Courtyard Plan as per Planning Submission

Amended Courtyard plan

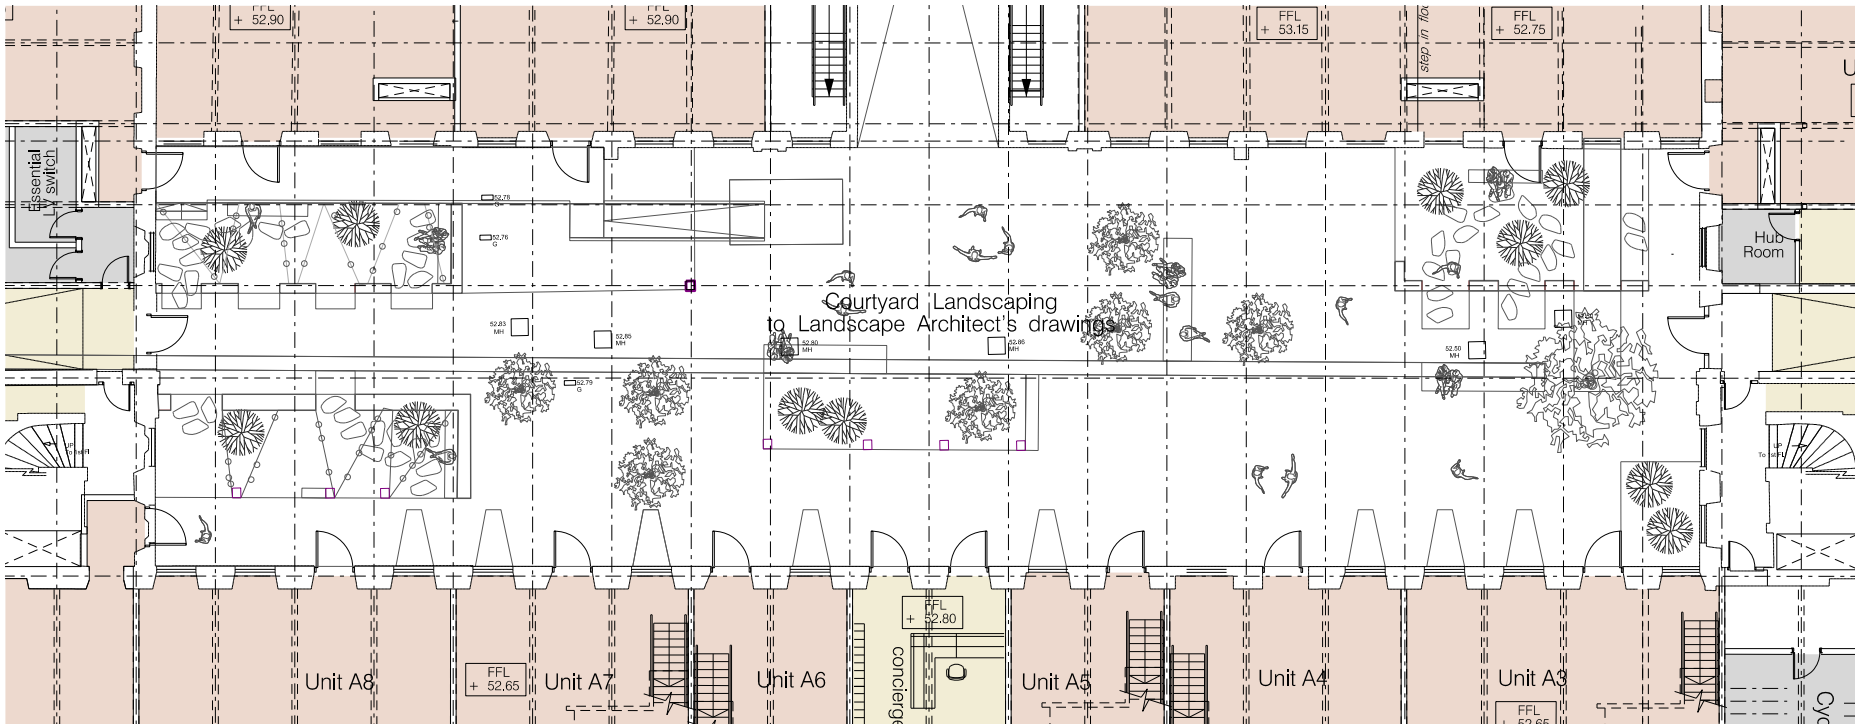
- Landscape strategy changed.
- Ramp to commercial unit omitted.
- All entrance thresholds level.
